Westinghouse
Electric Corporation

NSD-NRC-97-5079
DCP/NRC0823
Docket No.: STN-52-003

SUBJECT: RNS CONTAINMENT PENETRATION ISOLATION, KEY ISSUE #10

The AP600 design has been changed to conform to the staff position. The generic safeguards activation signal will be added to the logic to close the normal residual heat removal system containment isolation valves. The attached SSAR markups identify the changes that are required to implement this provision.

Figure 5.4-7

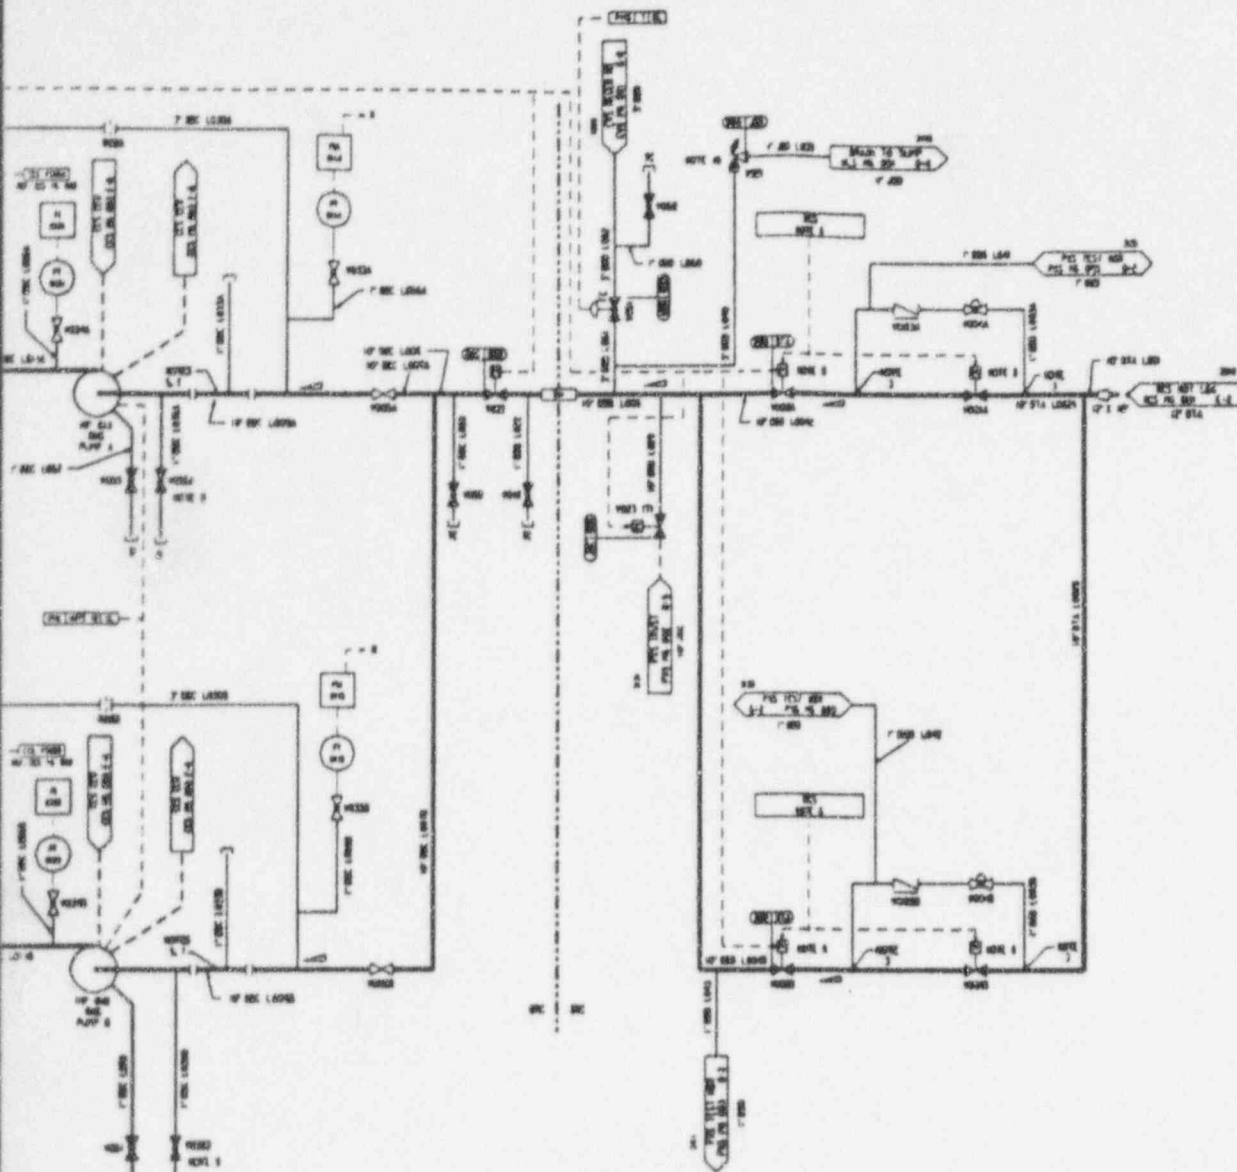
Valves close and pumps stop on high radiation and safeguards actuation signals.

Figure 7.2-1 (Sheet 13 of 20)

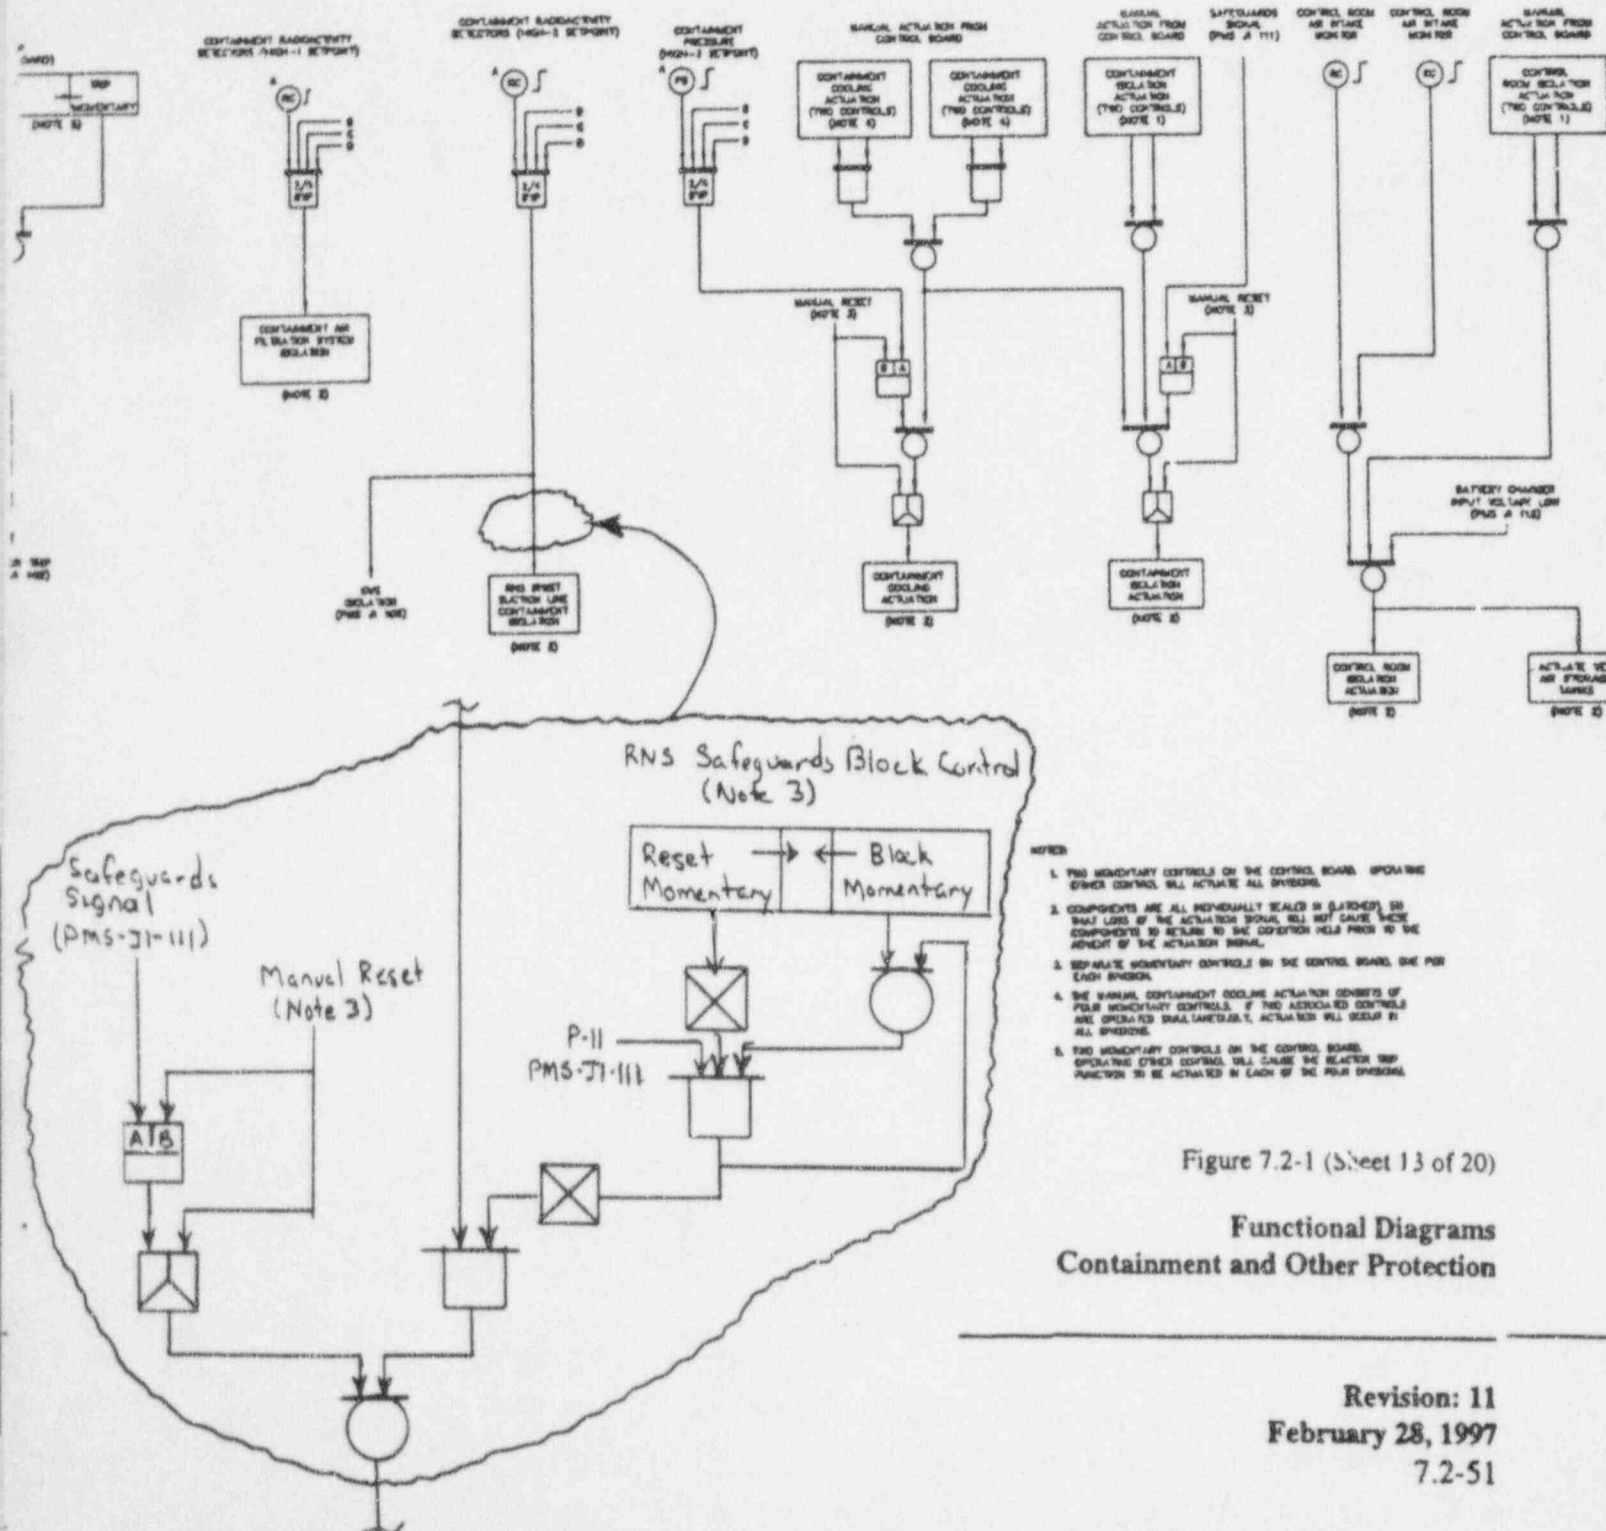
Signals for isolating the normal residual heat removal system lines are generated from any of the following conditions:

1. Automatic or manual safeguards actuation signal (subsection 7.3.1.1)
2. High containment radioactivity

The isolation signal generated as a result of Condition 1 can be manually reset to block the isolation of the normal heat removal system lines. This is done to permit the normal residual heat removal system to operate after the occurrence of a safeguards actuation signal. Separate momentary controls are provided for resetting each division.

Condition 2 results from the coincidence of containment radioactivity above the High-2 setpoint in any two of the four divisions. This actuation can be manually blocked when pressurizer pressure is below the P-11 permissive setpoint. This actuation is automatically unblocked when the reactor coolant system pressure is above the P-11 setpoint.

The functional logic relating to normal residual heat removal system isolation is illustrated in Figure 72-1, sheet 13.
